Staff Report

Infill Housing Design Review Committee

File Number: 8-C-21-IH

Location: 1520 Ohio Ave. **Parcel ID** 81 I P 003
Zoning: RN-2 (Single-Family Residential Neighborhood)
District: Lonsdale Infill Housing Overlay District

SITE PLAN

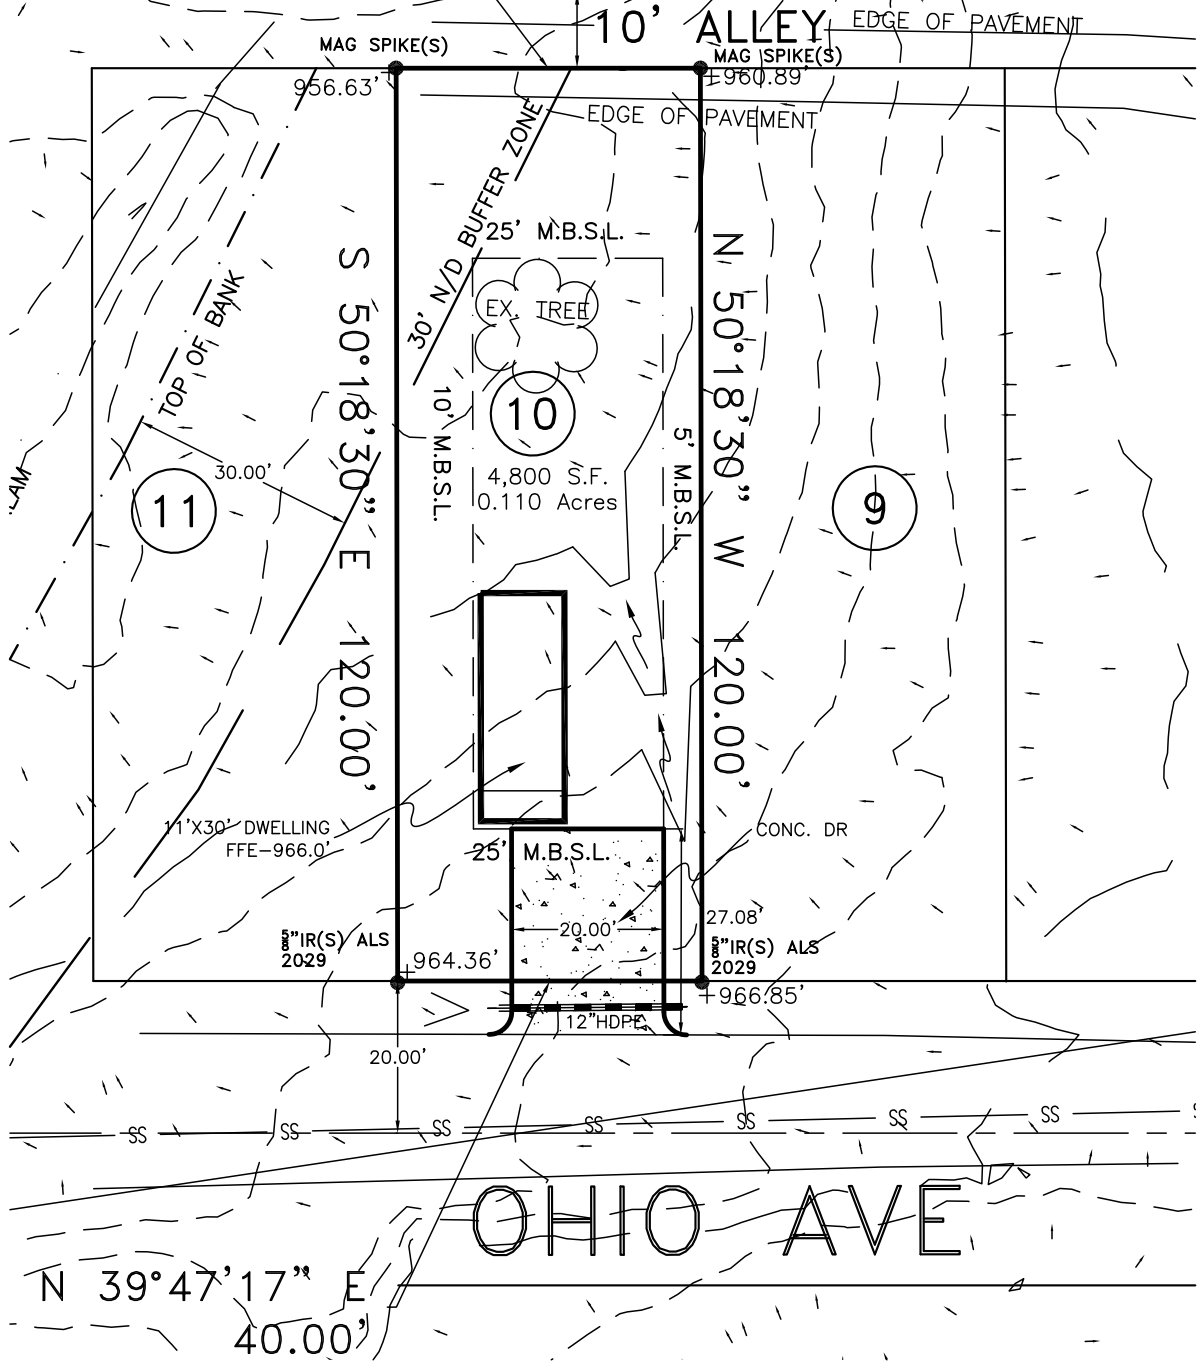
1. The house is proposed to be located 25' from the front property line. There are no other houses on the block of Ohio Avenue from which to draw context for a consistent front setback pattern. The RN-2 zoning prescribes a 20' minimum front setback (or the average of the blockface, whichever is less). The house should be moved slightly towards the front property line (to 20') to begin a consistent front setback pattern on the block, that is also in keeping with the base zoning. The final site plan should include a walkway from the street to the front door.

3. The proposed parking does not meet the Infill Housing design guidelines or City Engineering standards (front-yard parking is prohibited in the IH overlay; parking pads must have a max width of 18'). The site plan should be revised to place parking on the side of the lot or behind the house (at least 20' behind the front façade of the house with access limited to one lane between the street and front façade). Parking could also possibly extend off the alley, depending on the constraints of the buffer zone. Final site plan should meet City Engineering standards.

9. The site plan includes one existing tree in the rear. A second native or naturalized tree should be included in the front yard to meet guidelines.

- 1) Revise site plan to include a 20' setback from the house's main massing to the front property line and a walkway from the front door to the sidewalk or street;
- 2) Parking should be revised to meet Infill Housing design guidelines and City Engineering standards;
- 3) Include a square picket railing on the front porch and any additional detail elements recommended by the Board;
- 4) Include an additional window on the right elevation;
- 5) Use lap siding with an exposure and overlap comparable to historic siding patterns, and window trim;

6) Incorporate a new native or naturalized shade tree in the front yard.

RIGHT ELEVATION
SCALE: 0'-1/4" = 1'-0"

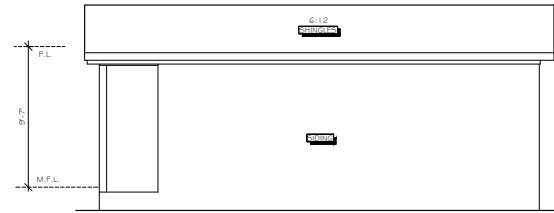
6. The proposed windows and door are limited in size and placement due to the small size of the house. An additional window on the right elevation (even a smaller, transom type rectangular window) would add some detail to a blank elevation with no transparency.
